Board of Zoning Adjustment
Staff Report
January 22, 2019

Case No:	18VARIANCE1120
Project Name:	S. 3 rd Street Variance
Location:	1118 S. 3 rd Street
Owner(s):	Sujatha S. Reddy Revocable Trust
Applicant:	Boz Lindgren, Lockett & Farley
Jurisdiction:	Louisville Metro
Council District:	6 – David James
Case Manager:	Zach Schwager, Planner I

3. Site Plan

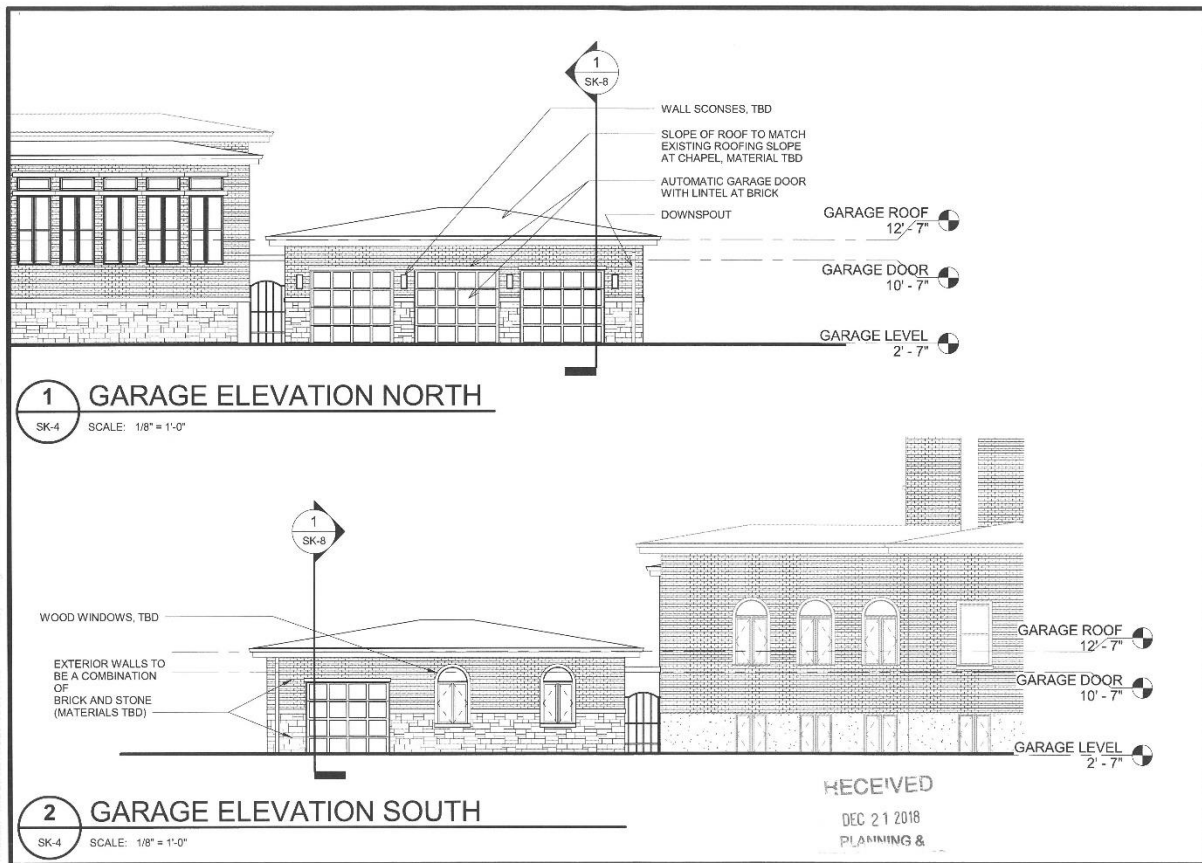
The subject property is located in the Old Louisville neighborhood and preservation district, and currently contains a 3-story residence. The applicant proposes to construct a 1-story detached garage and a 1-story dining room expansion. The proposed location of the accessory structure results in a reduced private yard area below the required 30% of the area of the lot. The applicant requests a variance to allow the reduced private yard area.

The applicant further requests a waiver to allow the use of an existing driveway and existing curb cut on S. 3rd Street, to allow access to the proposed detached garage from the front of the property. Land Development Code section 5.4.1.E.3 states that access to parking shall be achieved through a rear alley, except where rear alley access is not available.

- The plan has received preliminary approval from Transportation Planning on the condition that the waiver is approved or that access from Sherwood Avenue is discontinued.

STAFF: The requested variance will not cause a hazard or nuisance to the public as the existing private yard area is already completely paved. Also, the applicant is proposing green space to the side of the primary structure.

STAFF: The applicant has incorporated other design measures that exceed the minimums of the district to compensate for non-compliance with the requirements to be waived by turning a portion of the existing driveway on the southern side of the property into green space.

GARAGE ELEVATIONS
DWG # SK-6
REFERENCE:

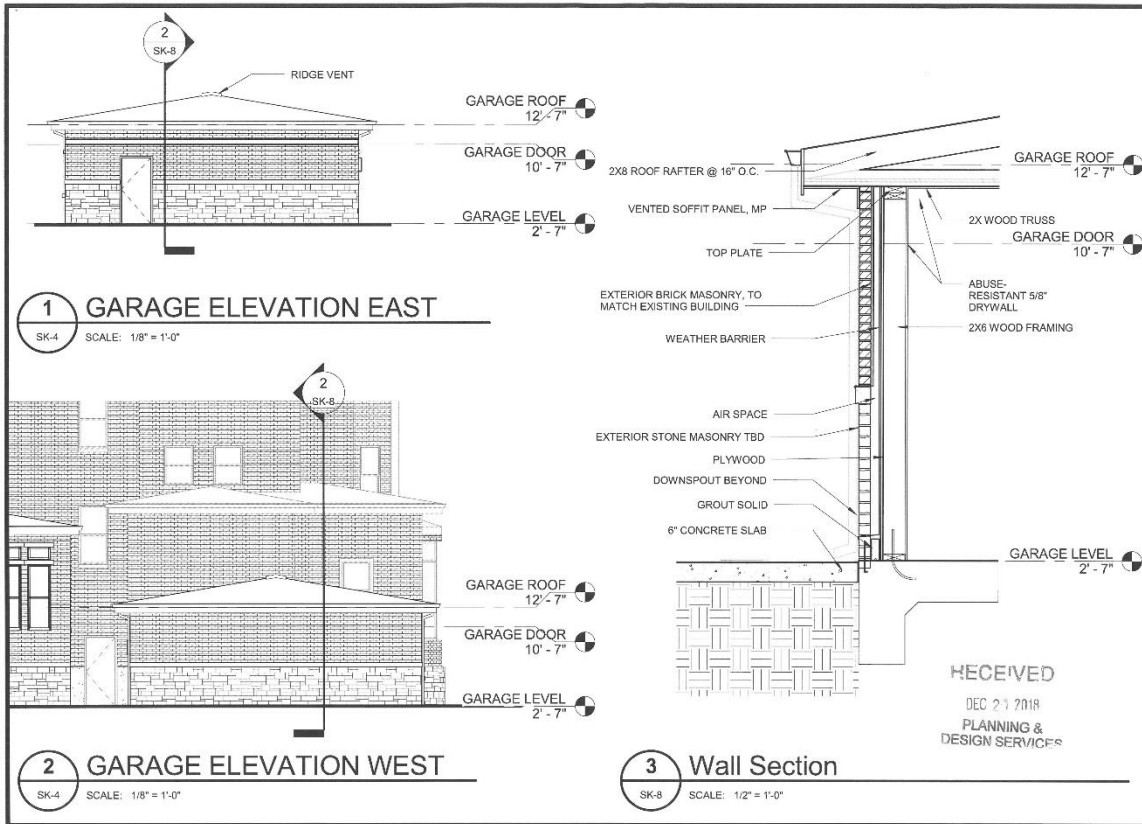
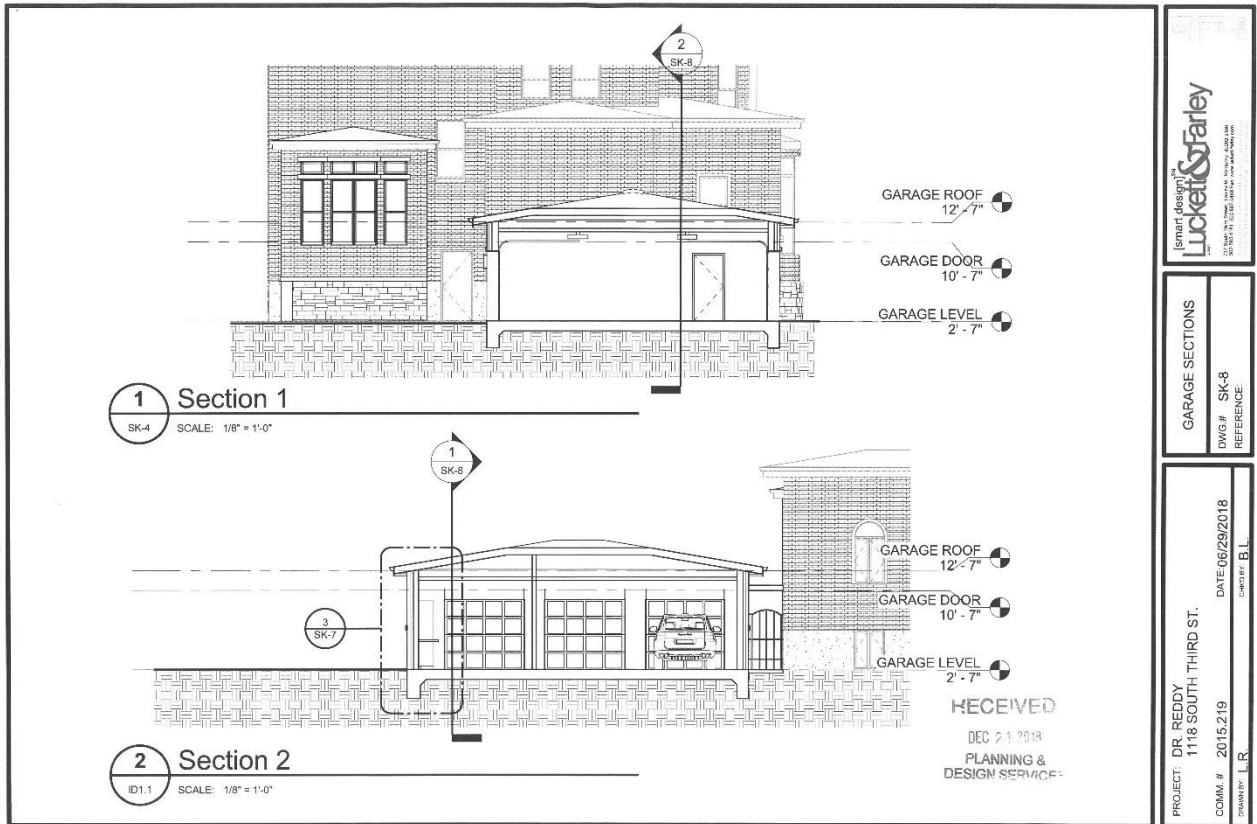
The proposed garage generally meets the design guidelines for Garage and New Construction-Residential. There are a variety of structure types along this particular alley. The proposed garage generally meets the applicable design guidelines for New Construction: NC3, NC4, NC5, NC6, and NC7 with the exception of directional emphasis (NC3). Most of the alley structures or garages have doors facing the alley. Since this garage will be accessed from the driveway/motor court the garage doors are proposed to be on the elevation at the motor court, not facing the alley. If the proposed 8' brick wall is approved then the garage will not be visible from the alley. A variance would be needed for not providing the required Private Yard Area. A waiver would be needed for not providing access from the alley.
